GOLLING MASERATI & ALFA ROMEO JZ19-28

GOLLING MASERATI & ALFA ROMEO JZ19-28 WITH REZONING 18.728

PLANNING REVIEW

Rezoning Request from NCC (Non-Center Commercial District) to B-3 (General Business) with Planned Rezoning Overlay (PRO)

SHEET
Dimensional Site Plan

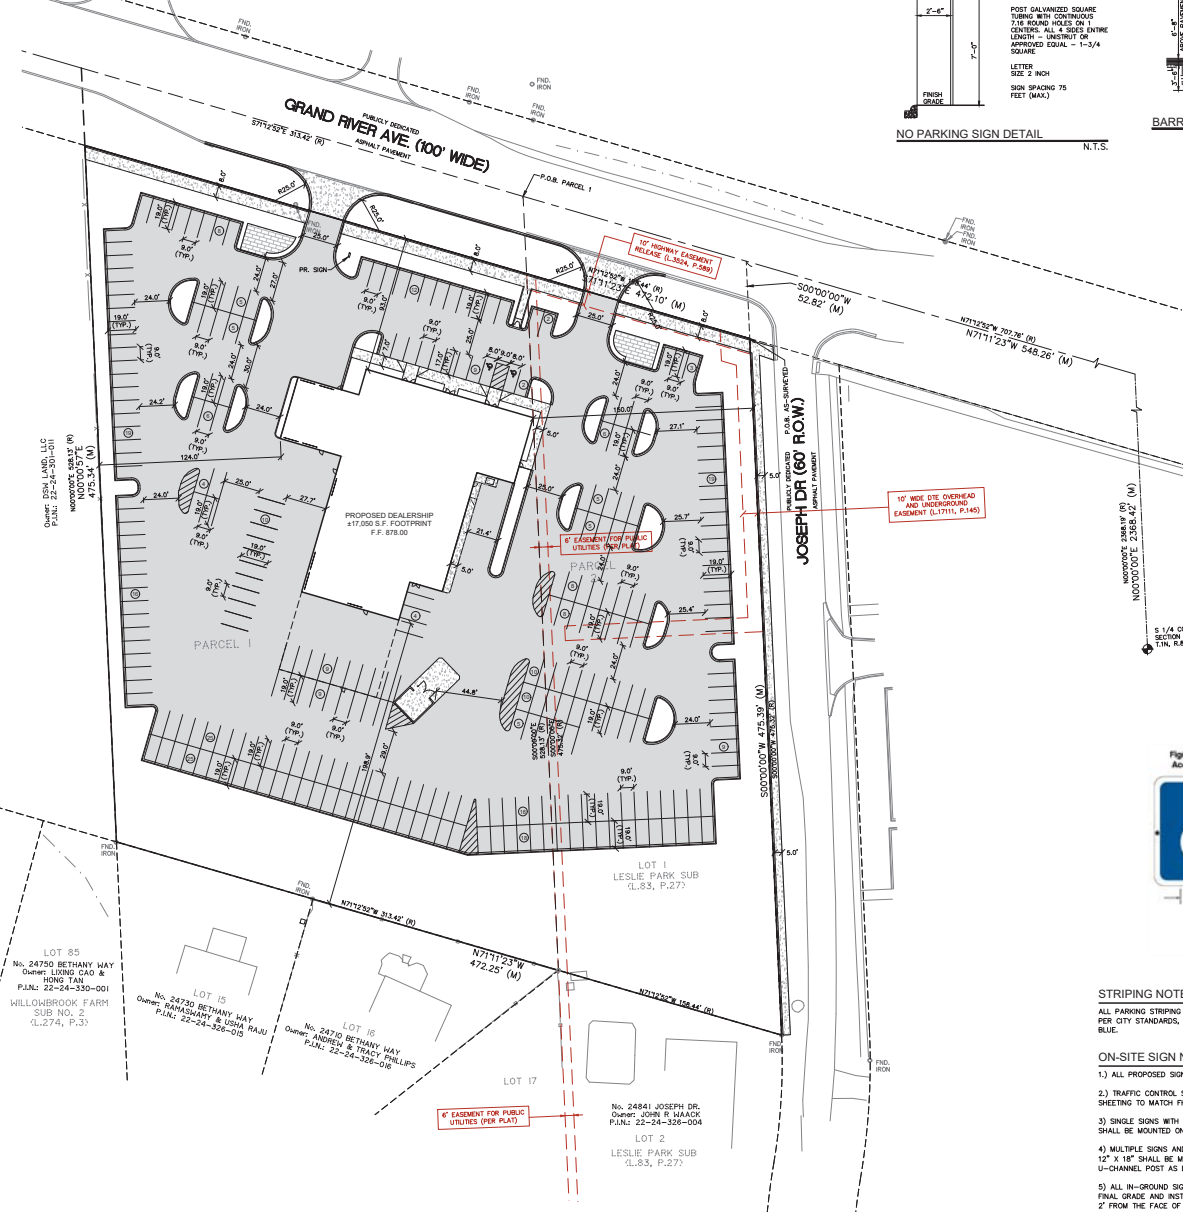
Staff Comment: The applicant must provide dimensions of same-side driveway spacing, as well as the measurement from the driveway to the intersection, in order to determine the total deviation requested and whether additional deviations are needed. The deviation is supported, as it allows for efficient circulation around the site without a curb cut onto Joseph Drive.

Staff Comment: The truck turning patterns are provided on sheet SP01. Those turning movements do not appear to encroach into any of the areas where the end islands are either painted or

absent. Therefore the deviation does not appear to be warranted, except for the justification for ease of snow removal. Eliminating the raised end islands also requires additional deviations for landscaping requirements that are not met (see additional deviations below). Substituting a painted parking island along the south property line results in a bay of 43 spaces. Staff believes the requested deviations do not provide an enhancement of the development that is in the public interest and do not meet the intent of the ordinance.

- 1) An additional tie has been added to the center post (All sheets).
- 2) A same-side driveway spacing deviation has been requested and dimensions have been added to Sheet C-2 to show spacing between drives and intersections.
- 3) It is noted that a ROW permit is required from the City of Novi for Joseph Dr. and Grand River Ave.
- 4) It is noted that a ROW permit is required from the Road Commission of Oakland County for Grand River Ave.
- 5) It is noted that a non-domestic user survey be provided to the city.
- 6) A list of signs and quantities, as well as all locations will be included in the site plan submittal.
- 7) All landscape plantings will be located outside utility easements, or minimally 5' from an underground utility. As utilities are finalized all plantings will be adjusted.

- a) Length of loading zone has been provided
- b) Aisle width to remain larger than 24' in areas for truck maneuvering.
- c) Additional island dimensions have been added to Sheet C-2.
- d) The trash receptacle is accessible by a trash collection vehicle and will not interfere with drive aisles or parking while in operation.

SHEET
 Landscape Plan

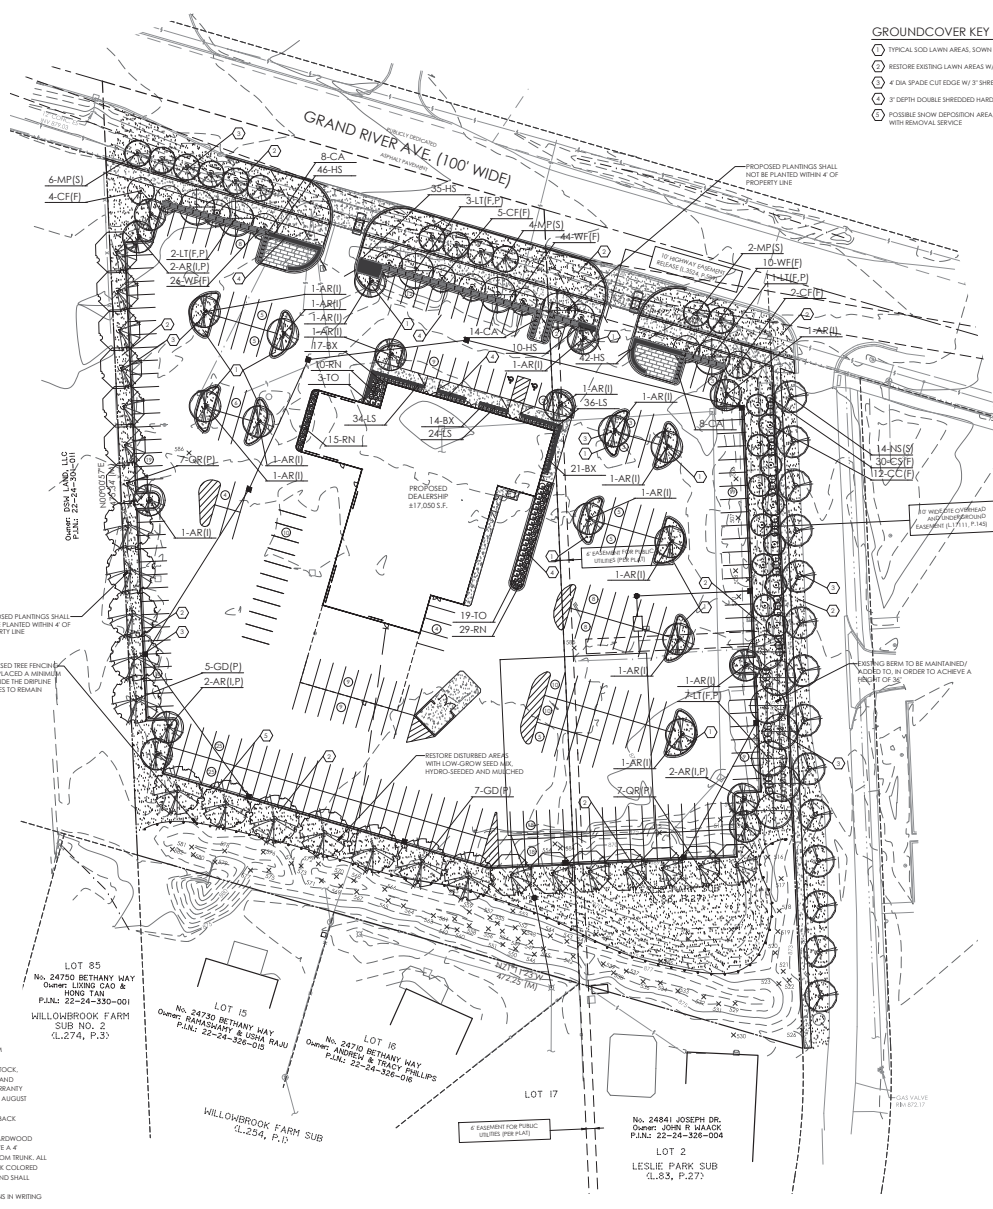
1. Adjacent to Residential Uses - Buffer (Sec. 5.5.3.A.ii and iii): The Ordinance requires a 6-8' tall landscaped berm, with 80% winter opacity and 90% summer opacity along the south border that abuts private residences. There is an existing 3-5 foot berm with evergreen trees existing on the site, which the applicant intends to retain. A landscape deviation is required for the deficiency in the berm height and screening. **This deviation is not currently supported by staff, as the tree inventory provided indicates many of the existing trees are in poor condition, and are not likely to provide the required screening opacity. The deviation does not represent an enhancement of the development that would be in the public interest. See Landscape Review letter for further comment. The applicant should refer to Section 5.5.3.A.vii. for the conditions under which the Planning Commission may waive the requirement for an earth berm or obscuring wall.**

2. ROW Greenbelt Berm (Sec. 5.5.3.B.ii, iii): A 3 foot tall berm with a 3 foot wide crest is required along both Grand River and Joseph Drive, between the road and parking/display areas. The plans indicate the existing berm along Joseph Drive will be enlarged to 36 inches in height, which meets the requirement. There is no berm proposed along Grand River Avenue, however a 3 foot continuous hedge is provided as an alternative. **Staff supports the deviation for lack of ROW berm along Grand River, because the hedge is provided as an alternative method of screening car headlights.**

4. Parking Lot Landscaping (Sec. 5.5.3.C.): There are 11 missing landscaped endcap islands, 1 missing interior island. **This requires a landscape deviation that is not supported by staff. The justification provided is not sufficient for this deviation, in the opinion of staff. Please add endcap islands and canopy trees where required.**
